Model Series 463 AMG: Active Distance Assist and
Active Brake Assist IC Message and DTC U0416FE

Topic number	LI54.71-P-078112
Version	7
Function group	54.71 - Camera and radar-assisted assistance systems
Date	12/11/25
Validity	463 AMG
Reason for change	Line connector part number update

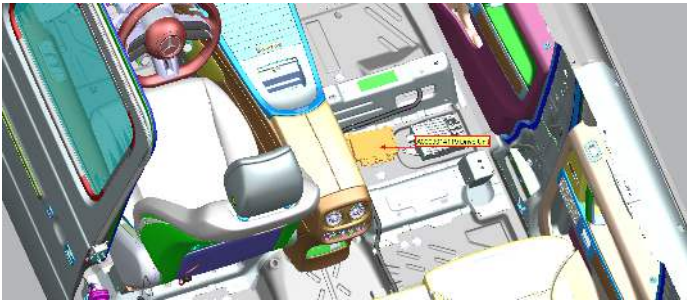
Missing wire between Drive Unit (N145) and Supercap (C8).

Professionally create a new connection by:

- Using a red/white cable with cross-section 0.35 mm² and overall length of approximately 2m.
- Connect Drive Unit (N145) plug A pin 18 to the 3-pin plug of the Supercap (C8) terminal 15 pin 2. Reference the new wire routing location as shown by the red line in "Picture 1 - Connection from Supercap to Drive Unit".
- The new wire should be added to the existing wiring harness as shown by the red line "Picture 1 - Connection from Supercap to Drive Unit".
- Z-Splice is the preferred method using A 000 982 91 10 for the Supercap (C8) connection.
